S T E W A R T

RECOMMENDATION MEETING

800 Stewart St, Seattle, WA

SDCI#3034006-EG

Level P4 Plan - Typical Residential Parking Proposed

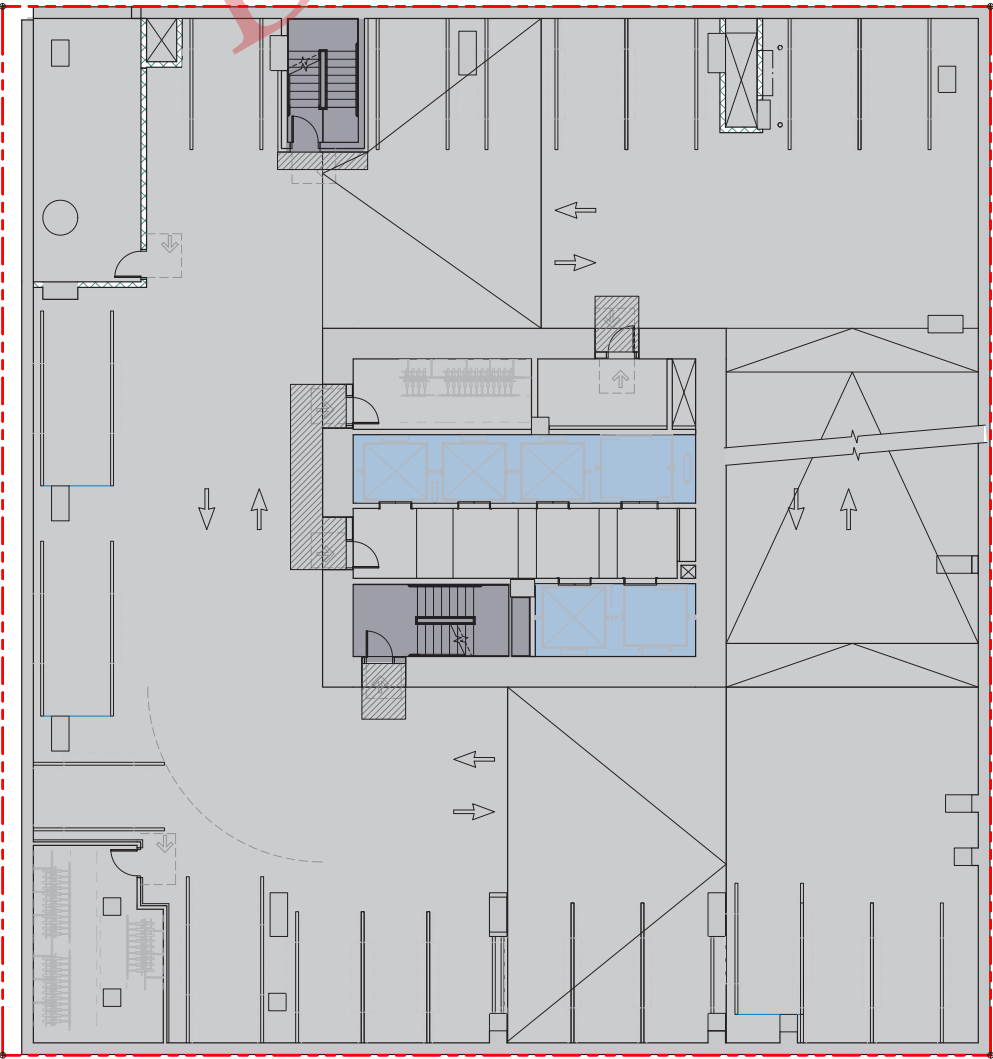
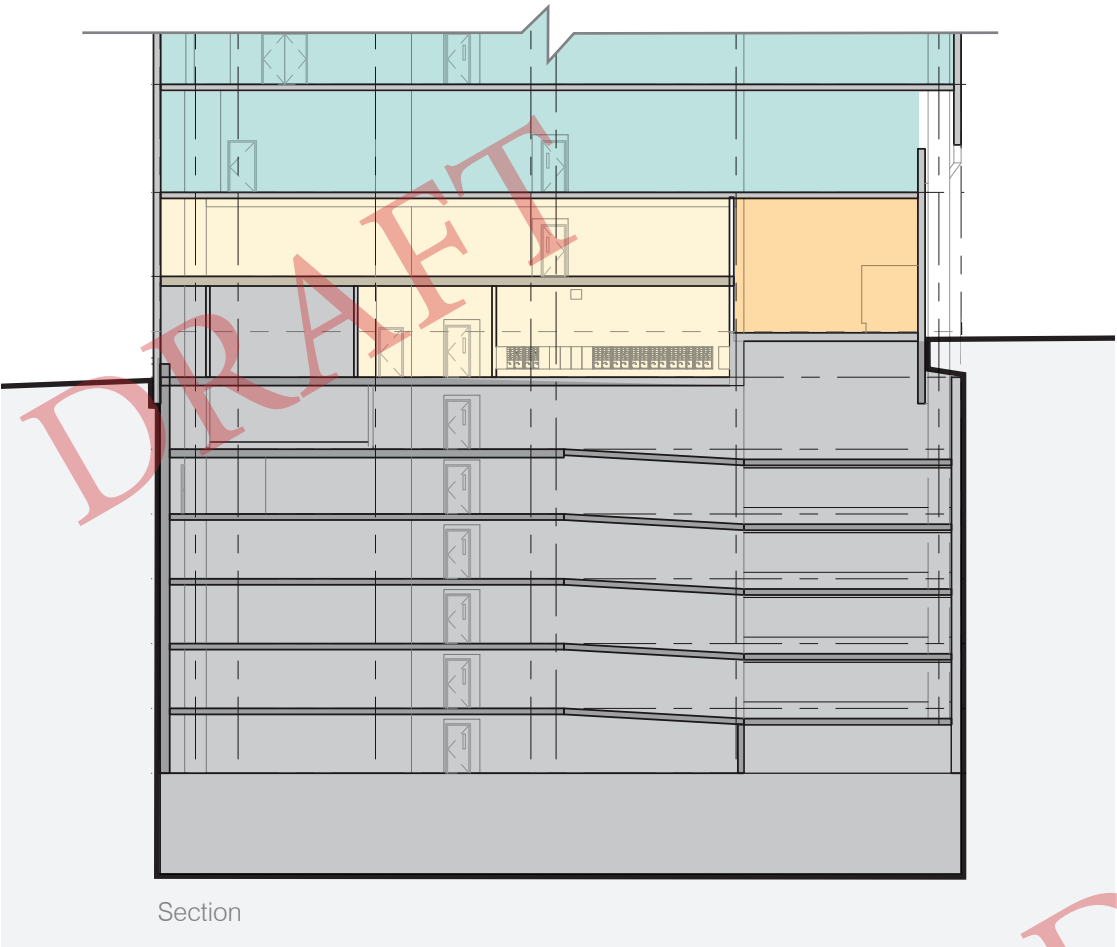
A minimum of 60% of the parking spaces shall be striped for medium vehicles.

Based on the confines of the site, project team is proposing to provide 31 medium size stalls (35%) instead of 51 medium size stalls (60%) in residential parking per SMC.

Providing 60% medium parking stalls is not dimensionally feasible due to site constraints. Medium stalls, consistent with the requirements for the residential parking, are proposed or the non-residential parking. The proposed design seeks to avoid above grade parking, maintain the proposed pedestrian oriented street-level design/uses, and to create as efficient a parking layout as possible, by spacing the structure efficiently and maximizing parking stalls. Smaller stalls help increase parking efficiency, and thus prevent the need for above grade parking. In an urban environment such as this site, this strategy promotes the use of smaller more fuel-efficient cars, which have, in turn, a smaller carbon footprint and are easier on the environment.

Perspective along 8th Ave (Top)
Level 1 Plan - Column Grid (Bottom)

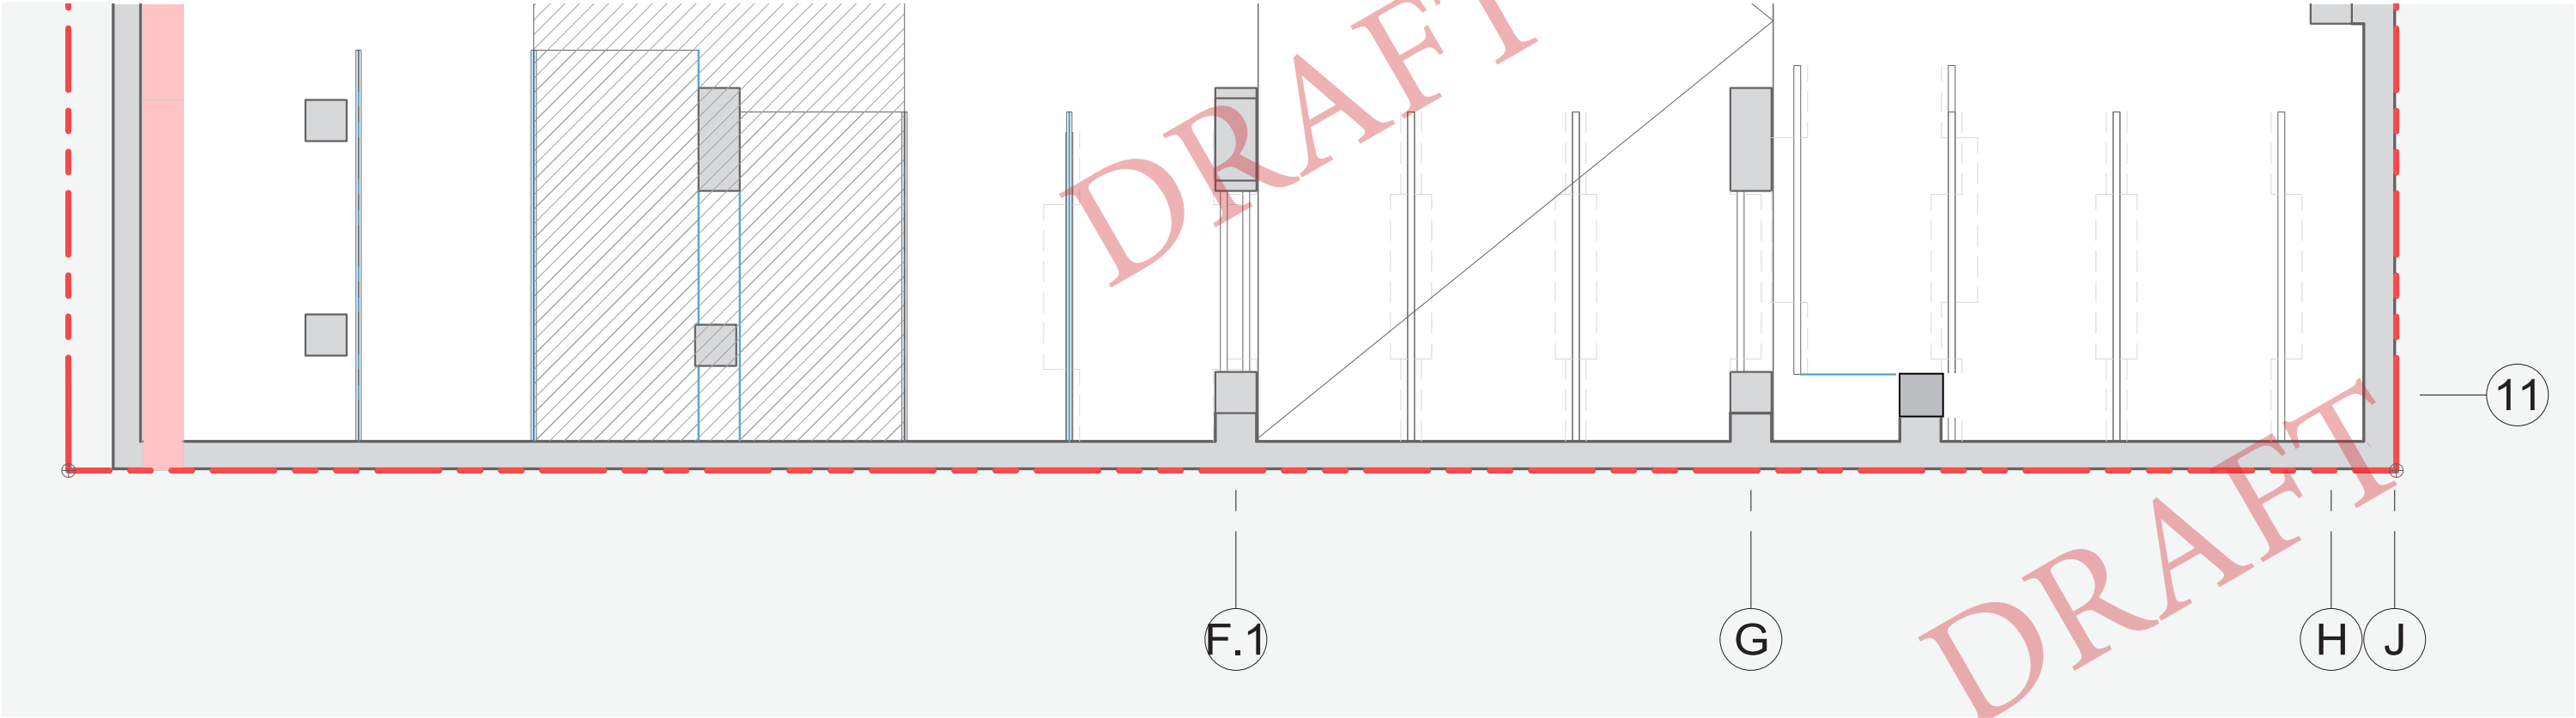
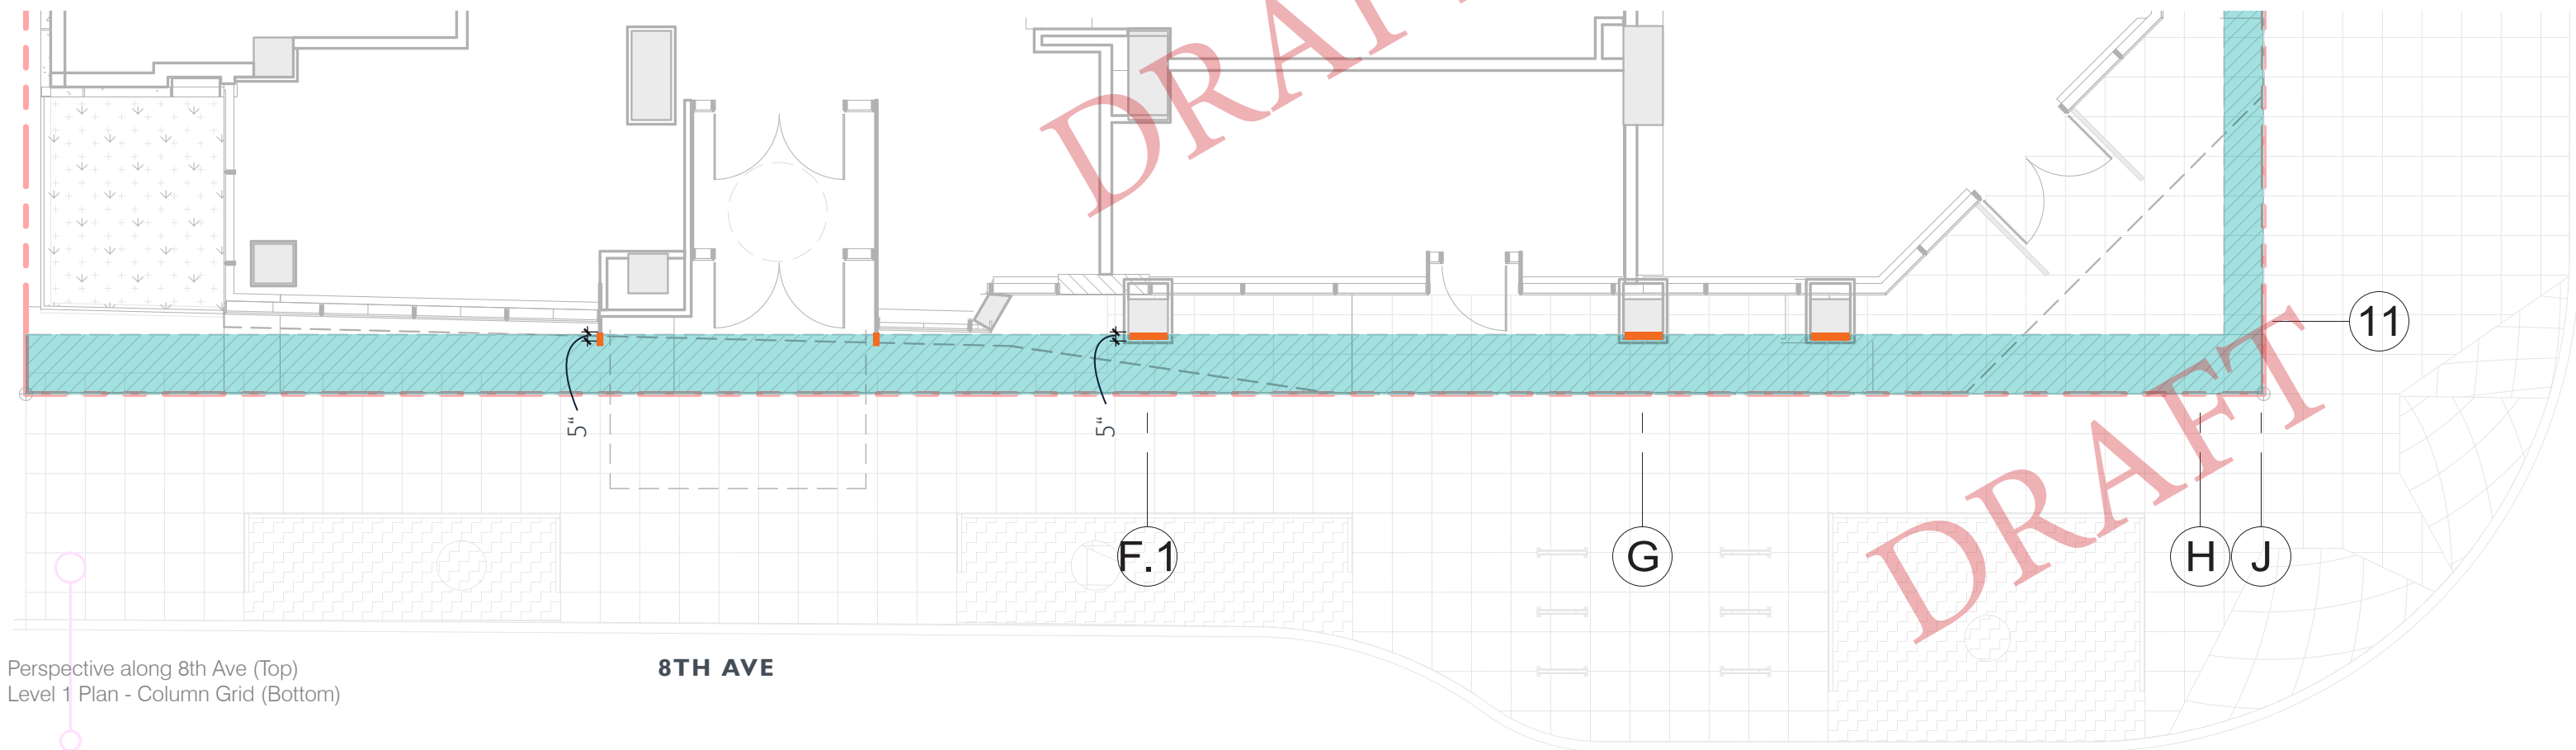
Minimum sidewalk widths are established for certain streets by Map 1C [9]. If a new structure is proposed on lots abutting these streets, sidewalks shall be widened, if necessary, to meet the minimum standard. The sidewalk may be widened into the right-of-way if approved by the Director of Transportation.

The three exterior structural columns with finishing cladding along 8th Ave (column grid 11) and the residential entry portal steel frame land five inches inside the 8th Ave sidewalk widening setback within the property line. 3 columns x 2'-5" wide x 5" encroachment = total of 3.02 sf (0.89%) out of the sidewalk widening area on 8th Ave (3 ft setback x 113 ft site width = 339 sf). The sidewalk setback requirement is only up to 8 feet in height.

The exterior columns bring a pronounced architectural gesture and vertical rhythm for pedestrian scale and experience at the corner of 8th Ave and Stewart St. The columns will be cladded with metal panel, providing a layer of material texture on the street level. The current column spacing are designed to efficiently accommodate for the spatial requirements of the underground levels as well as the residential units in the tower. With the tight square footage constraints on this site, the design team is able to accommodate for the sidewalk widening at Stewart Street and requesting a departure to allow the three exterior column locations at 8th Ave (highlighted) to encroach into this setback area to the amount of 5". Additionally, as part of the design of the residential entry portal and in conjunction with board guidance to strengthen the entry expression, the design team is requesting that the blackened steel frame also encroach into this setback area to the amount of 5".
